**SOLICITATION AMENDMENT
MODIFICATION DE L'INVITATION**

Title - Sujet Mechanical Upgrades	
Solicitation No. - N° de l'invitation EW038-181191/A	Amendment No. - N° modif. 005
Client Reference No. - N° de référence du client CSC-EW038-181191	Date 2017-10-26
GETS Reference No. - N° de référence de SEAG PW-\$PWU-201-11191	
File No. - N° de dossier PWU-7-40117 (201)	CCC No./N° CCC - FMS No./N° VME
Solicitation Closes - L'invitation prend fin at - à 02:00 PM on - le 2017-10-31	Time Zone Fuseau horaire Mountain Daylight Saving Time MDT
F.O.B. - F.A.B. Plant-Usine: <input type="checkbox"/> Destination: <input type="checkbox"/> Other-Autre: <input type="checkbox"/>	
Address Enquiries to: - Adresser toutes questions à: Ho (RPC), Hector	Buyer Id - Id de l'acheteur pwu201
Telephone No. - N° de téléphone (780) 901-0989 ()	FAX No. - N° de FAX (780) 497-3510
Destination - of Goods, Services, and Construction: Destination - des biens, services et construction:

This Amendment #005/Addendum #003 has been raised to make the following changes and to extend the closing date:

**EDMONTON MAXIMUM
SECURITY INSTITUTION**

ADD3-MSK01

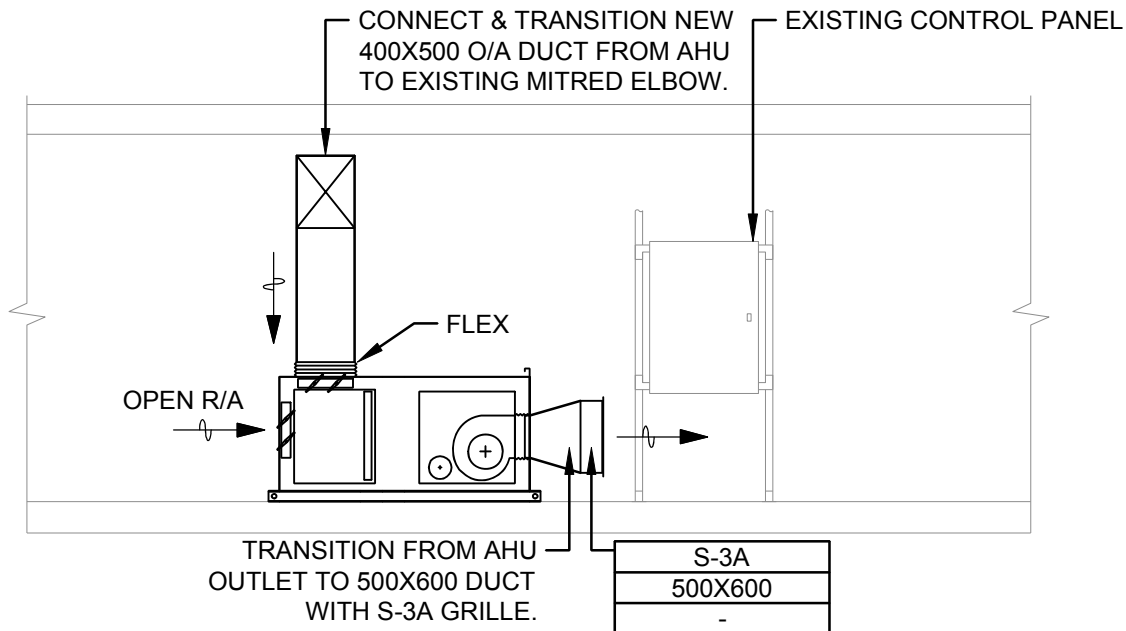
5.1	Revision: M61 – SECTIONS 2 1. Add Section as shown in attachment “ADD3-MSK01”
-----	--
